3 Draft EIR Text Revisions

This chapter presents revisions to the Corte Madera Creek Flood Risk Management Project, Phase 1 (project) Draft EIR that was published on February 1, 2021. These revisions include both (1) changes made to text, tables, or figures in response to comments on the Draft EIR as discussed and presented in Chapters 2 and 3, as well as (2) staff-initiated text changes to correct minor inconsistencies, to add minor information or clarification related to the project, and to provide updated information where applicable. None of the revisions or corrections in this chapter substantially change the analysis and conclusions presented in the Draft EIR.

Figure 2.5-2 Project Elements (Map 2 of 3)

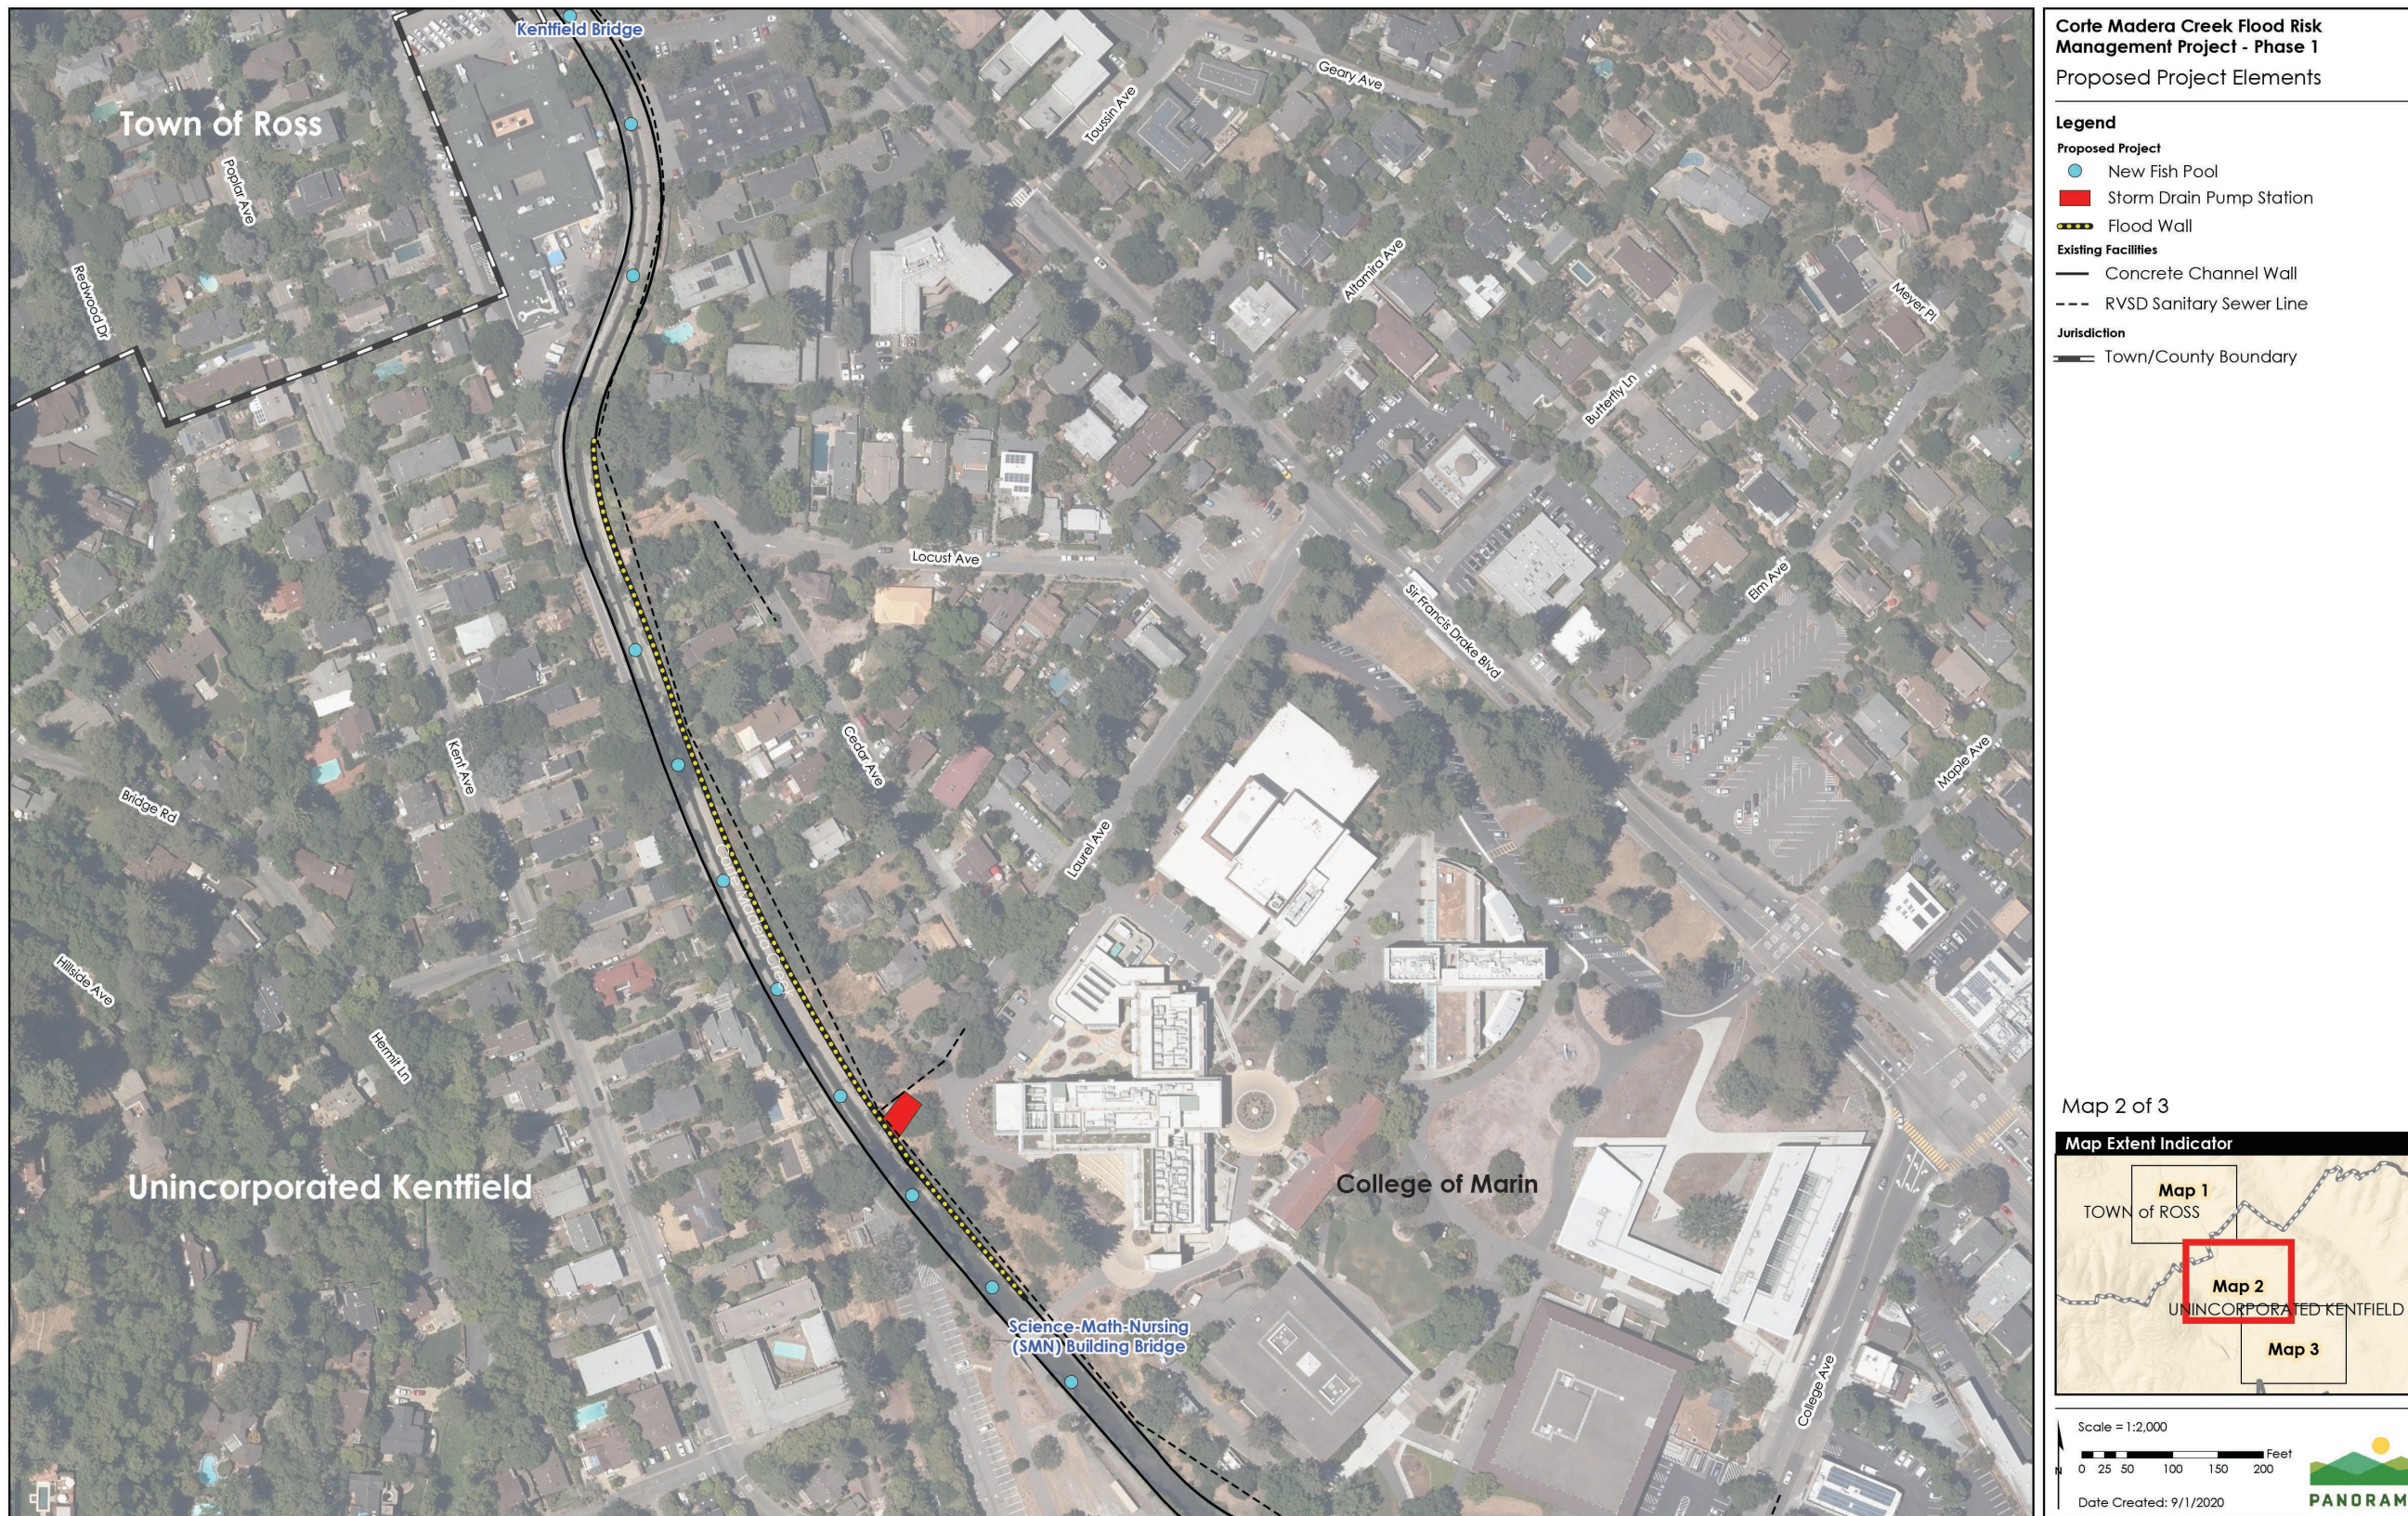
In response to comment A5-8, Figures 2.5-1 to 2.5-3 in the Draft EIR (pages 2-9 to 2-11) have been revised as follows to show the existing concrete channel walls on both sides of the channel:

Figure 2.6-1 Staging, Stockpile, and Temporary Work Areas

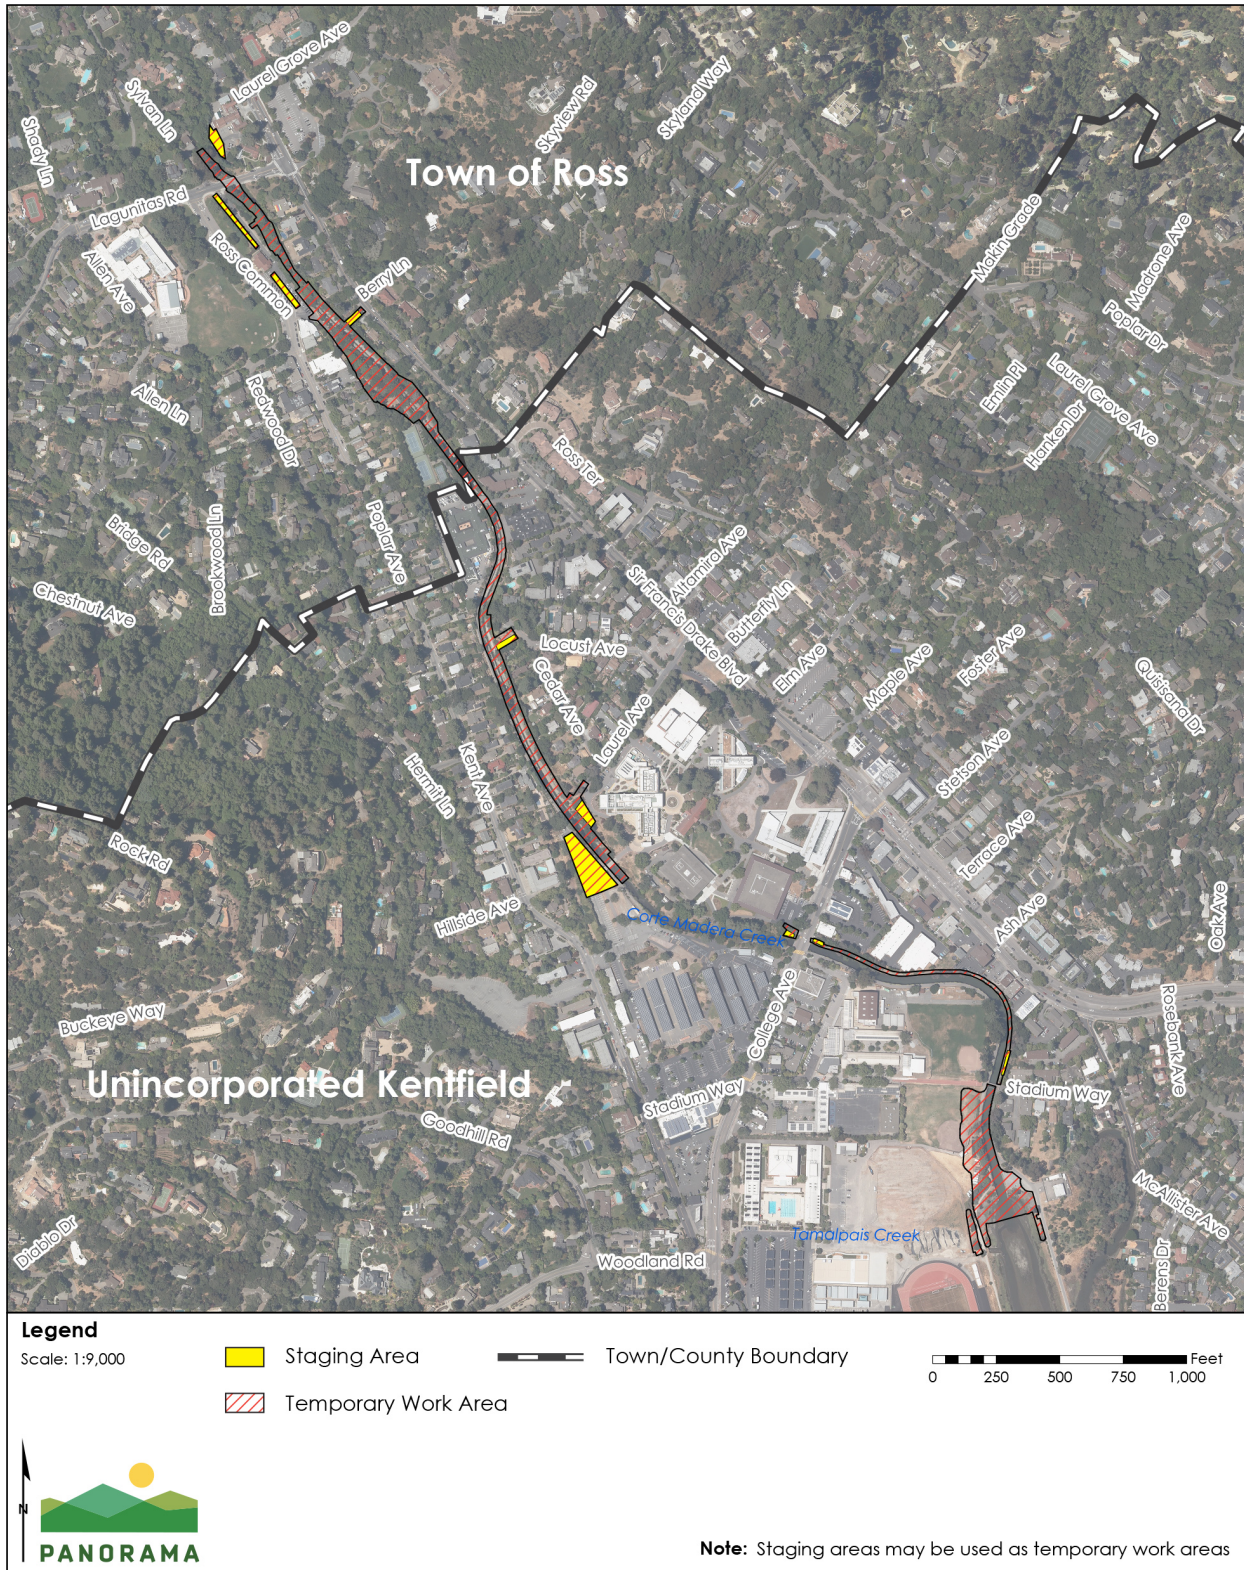
In response to comments B1-25 and B1-31, Figure 2.6-1 in the Draft EIR (page 2-27) has been revised, as shown on the following page.

Figure 3.2-2 Sensitive Receptors within 1,000 Feet of the Project Area

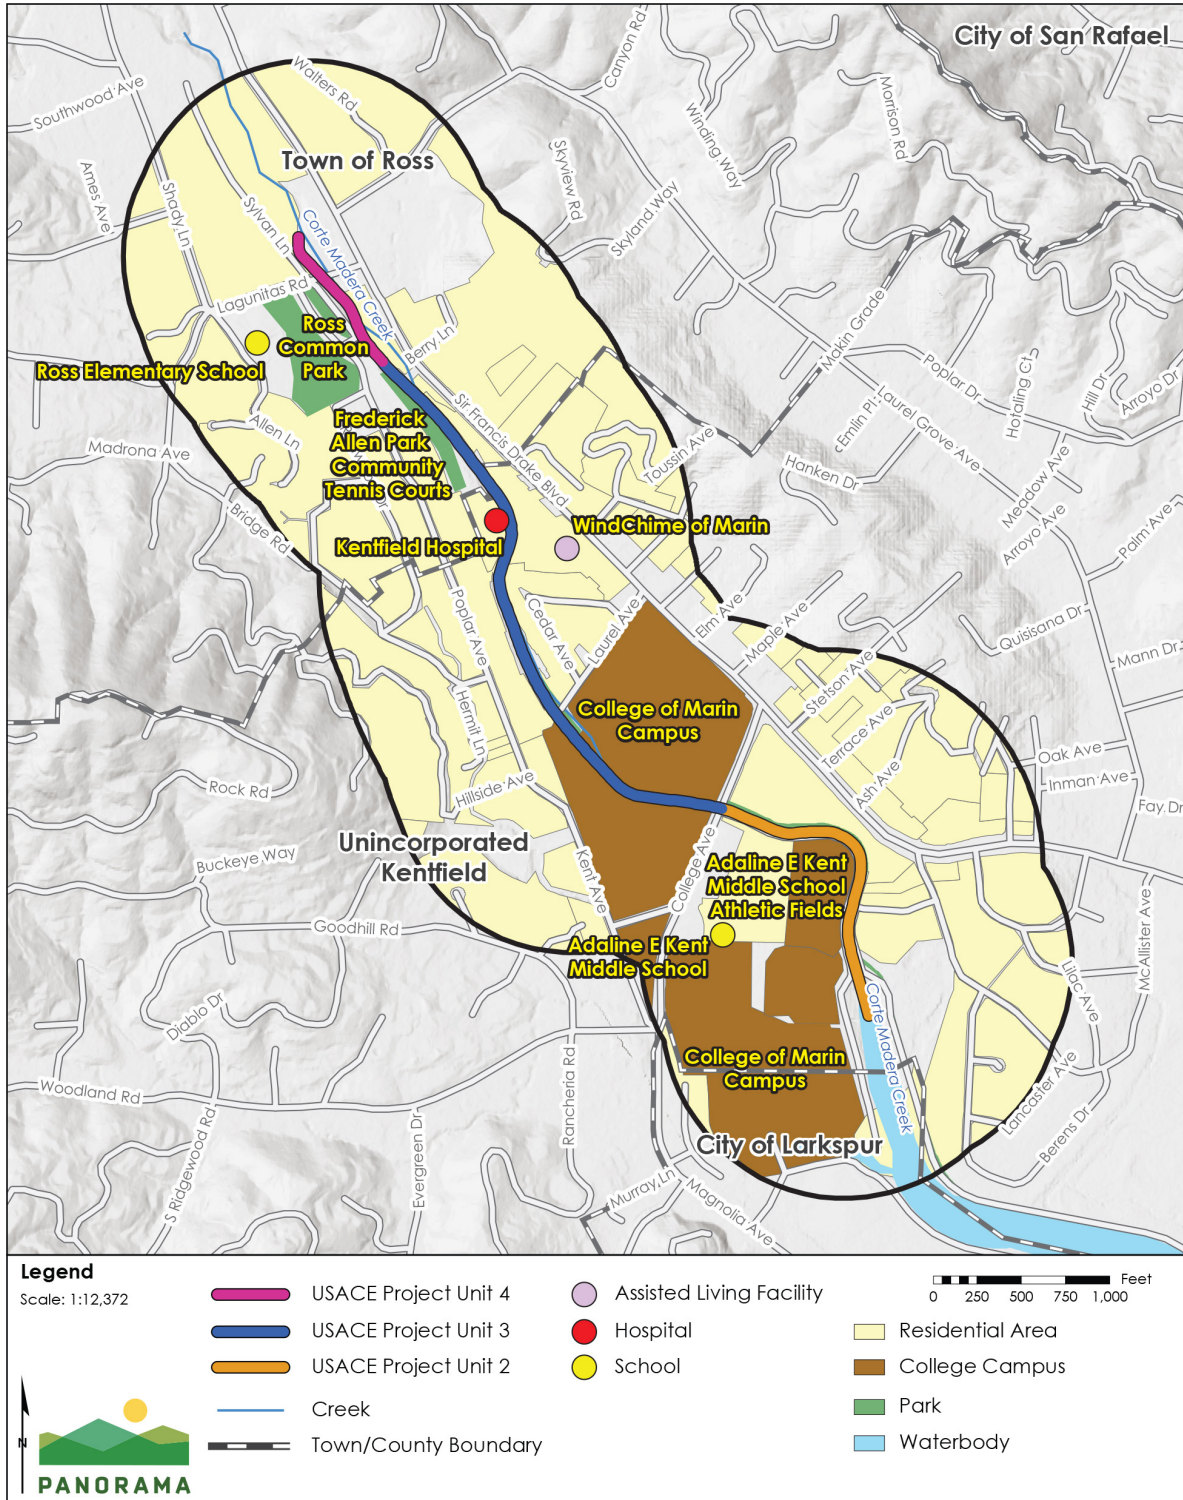
In response to comment B1-33, Figure 3.2-2 in the Draft EIR (page 3.2-12) has been revised, as shown on the following page.

Figure 3.3-3 Habitat Types within Project Area (Map 3 of 3)

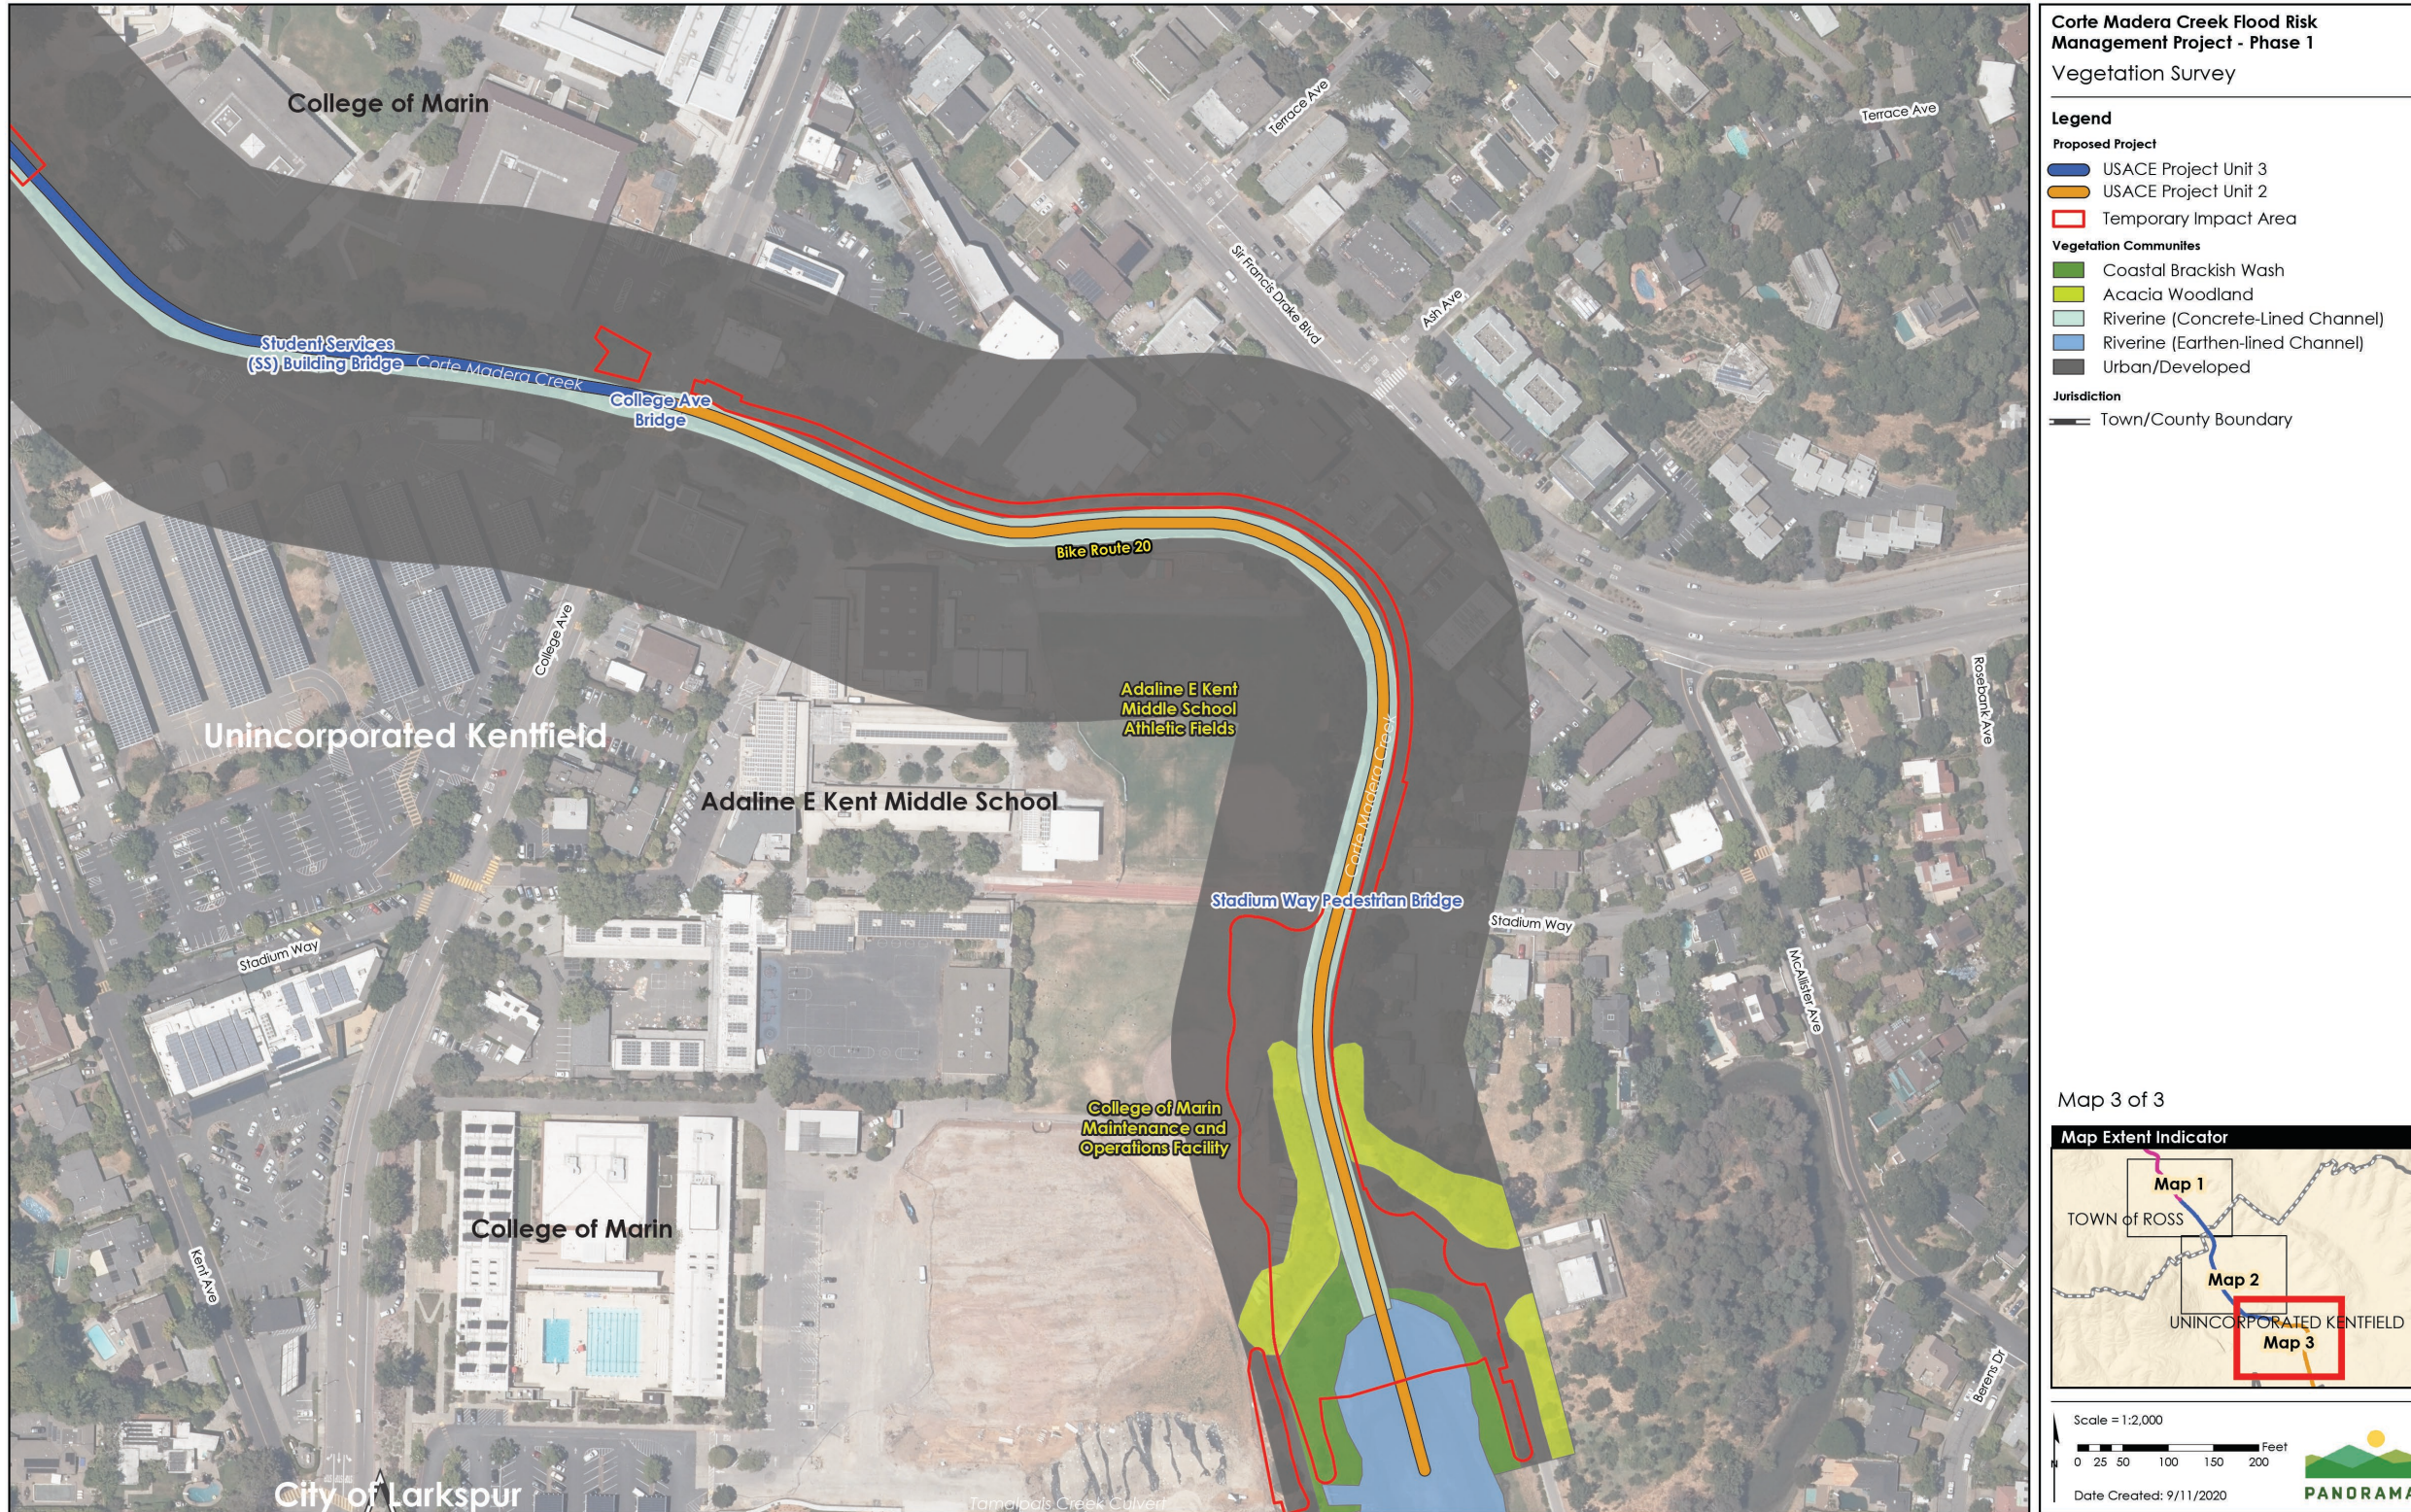
In response to comments B1-25 and B1-31, Figure 3.3-3 in the DIER (page 3.3-11) has been revised, as shown on the following page.
